TELECOMMUNICATIONS
H 447 Mod Instr No 2

WIRELESS SET C42

TECHNICAL HANDBOOK - MODIFICATION INSTRUCTION

Fig 3 - Circuit after modification

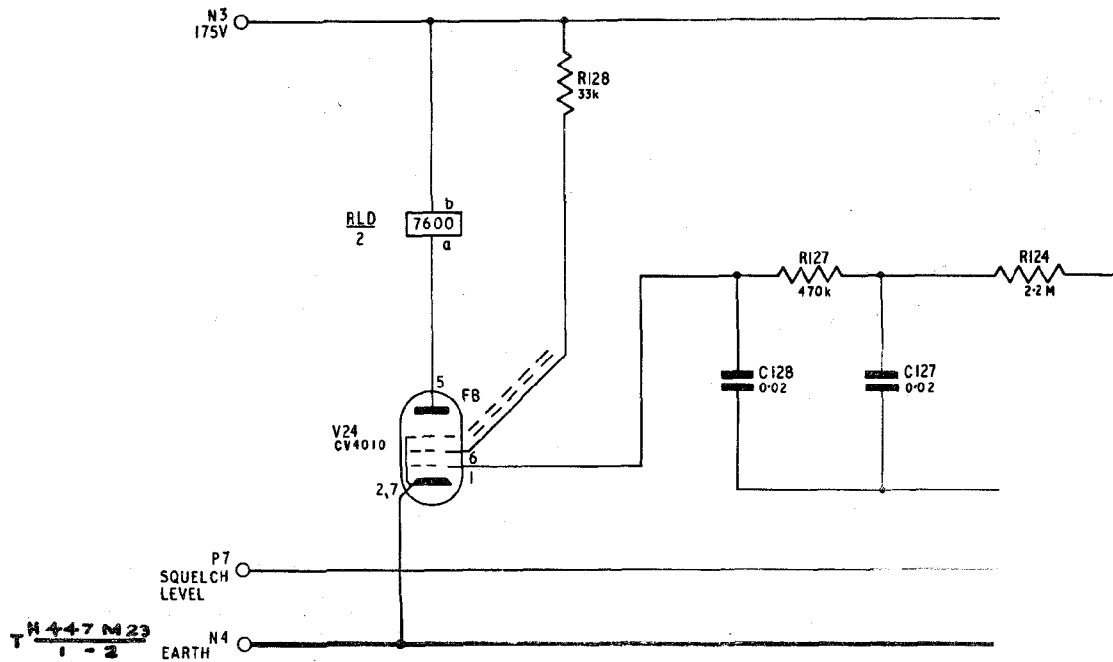
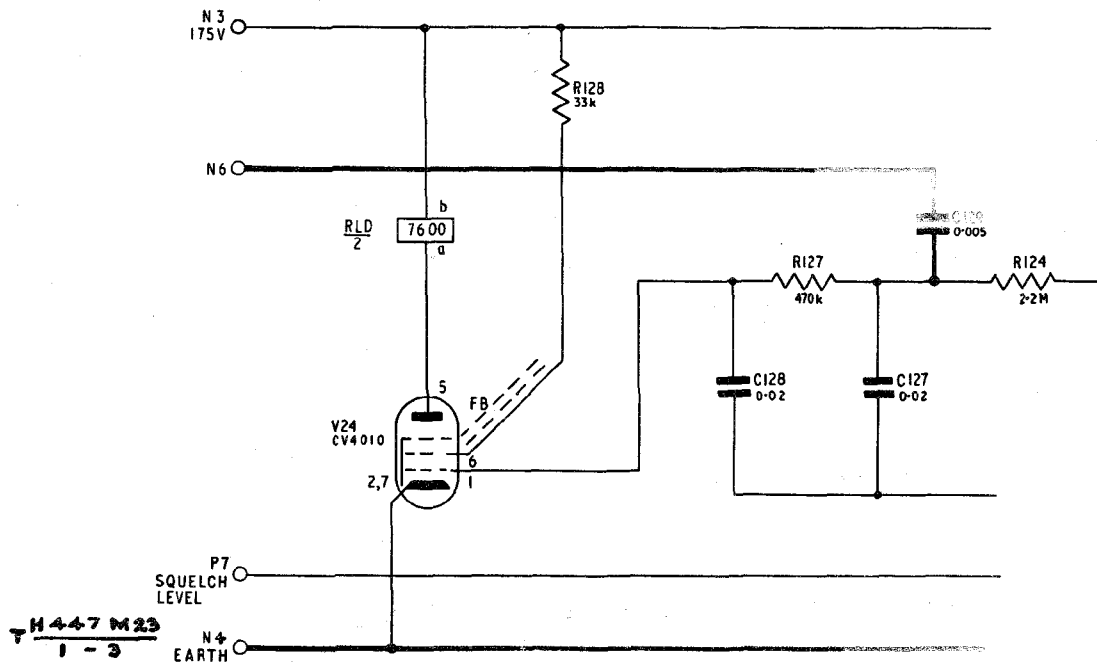
This regulation details the work necessary to add a capacitor, (C129), the action of which is to apply a 'speed up' pulse from the h.t. of the transmitter section of the r.f. unit to the grid of valve V24, rapidly removing the residual charge from the squelch circuit, and thus ensuring a rapid operation of the squelch unit relay, and also the addition of a wire to the A frame Wiring harness, branched. This instruction also details the procedure for the fitting of an extended (figures 21 to 40 inclusive) modification record plate, to the front panel assembly of the TRC42 No 1.

- a. Tels H 442, Part 2, Issue 3, dated 29 May 65
 - (1) Fig 2505 to show changes illustrated in Fig 3.
 - (2) Table 2511 to show wiring details for terminal N6 to M12.
- b. Tels H 442, Part 2, Issue 2, dated 9 Mar 62
 - (1) Fig 2518 to show the changes illustrated in Fig 1 and 3.
 - (2) Table 2506 to show new capacitor C129 details added to the component schedule.

Fig 4 - Drilling detail for mod record plate

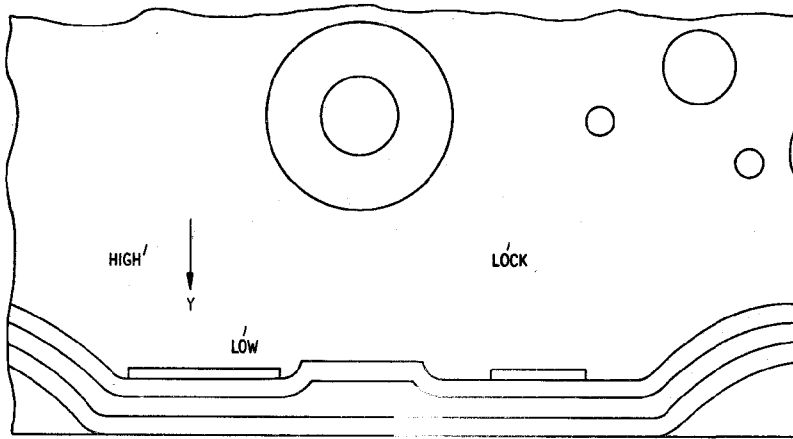
- o. Drill four 0.067 in. diameter holes (No 51 drill) in the bottom flange of the front panel of the TRC42 No 1 to the dimensions detailed in Fig 4.
- p. Fit and secure the modification record plate by means of the four Screws, drive inserted from the inside of the flange.

Fig 1 - Simulator, antenna, modified circuit diagram and layout

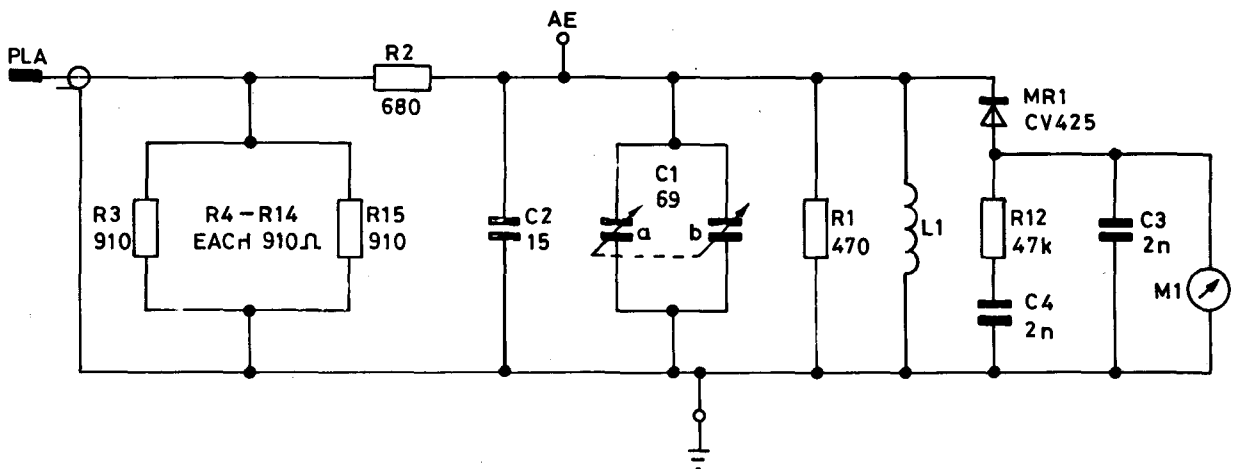
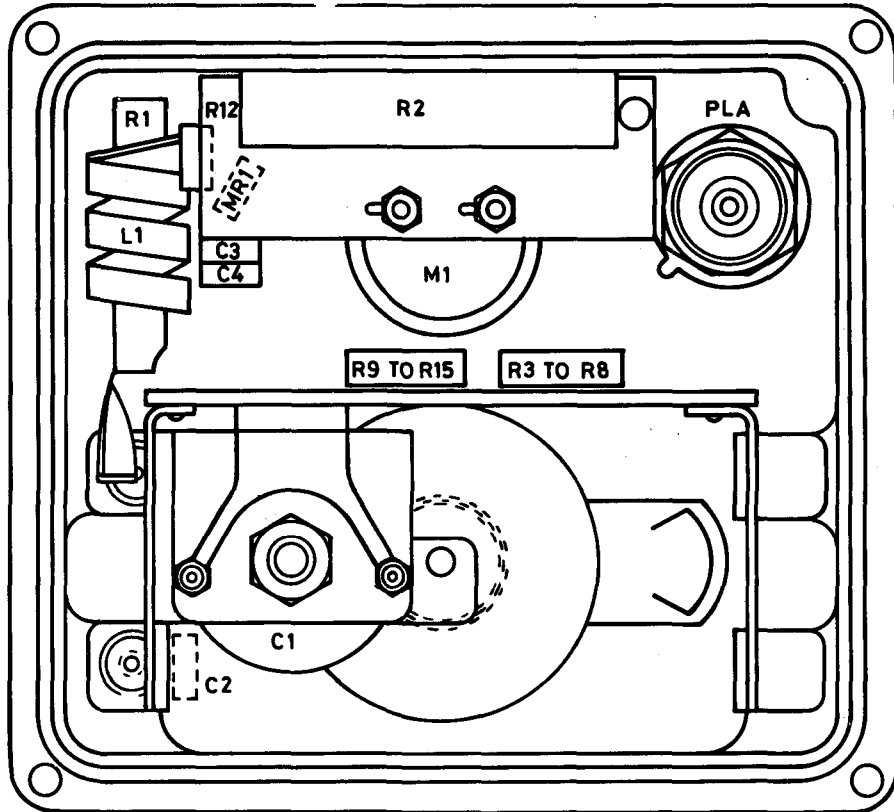
1. Resistors 680Ω, 5905-99-027-1216 used in circuit positions R3 to R11 are no longer available for new production antenna simulators. Twelve resistors 910Ω, ±5%, 2W, Z30/5905-99-646-0707, are being fitted by the manufacturer instead of the nine 680Ω resistors. The new resistors will be identified by circuit references R3 to R11 and R13 to R15 and are mounted on a new PCB. Simulator units embodying the new resistors are identified by having the figure 3 struck through on the modification record plate. There is no provision for modifying simulators not modified in production. The modified layout and circuit diagram are given in Fig 1.

NOTE 1: In latest simulators twelve resistors fitted, R3-R11 and R13-R15, 910Ω. Refer to Tels H 447 Mod Instr No 26, Fig 1, for modified circuit diagram and layout.'

Fig 1 - Crystal unit assembly showing the new socket and the modification kit item numbers.

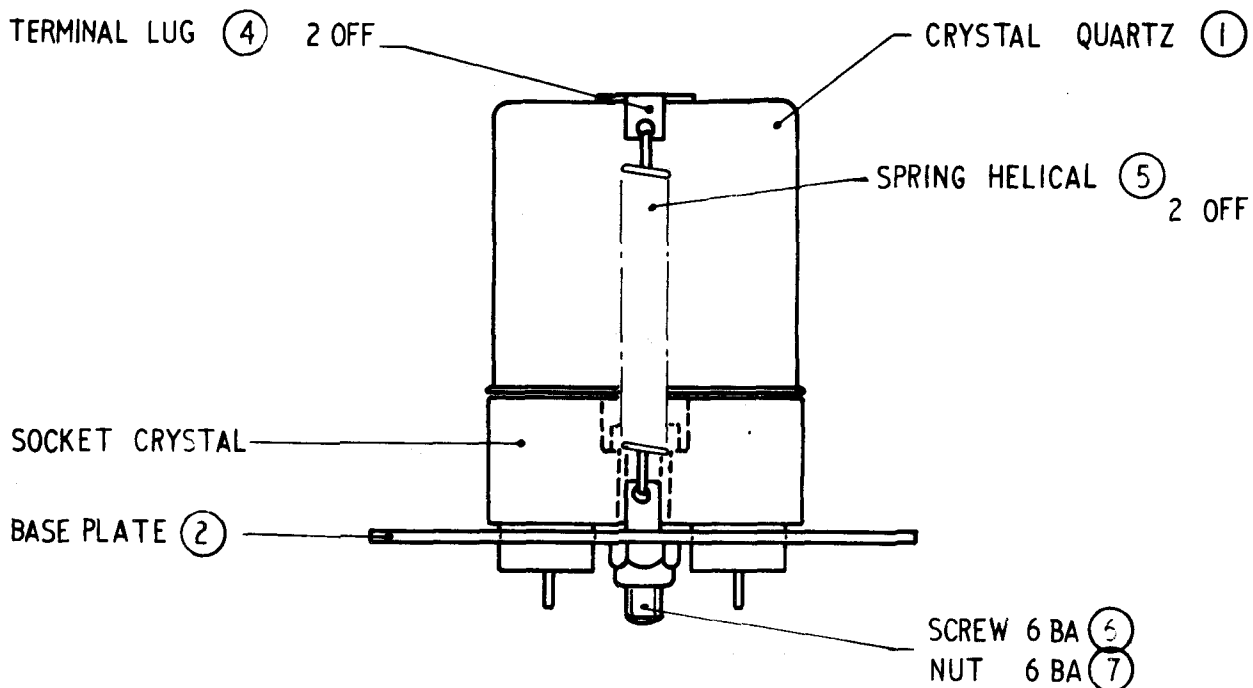
- j. Remove and retain the two 6 BA screws holding the crystal socket on the chassis. Remove and discard the socket.
- k. Referring to Fig 1 assemble the new quartz crystal socket with the Base Plate, Sub para 8.a., Item 2, and the Crystal Retainer Assembly, Item 3, using Item 4, two Terminal Lugs, Item 5, two helical springs, Item 6, one 6 BA screw and Item 7, one self locking nut.
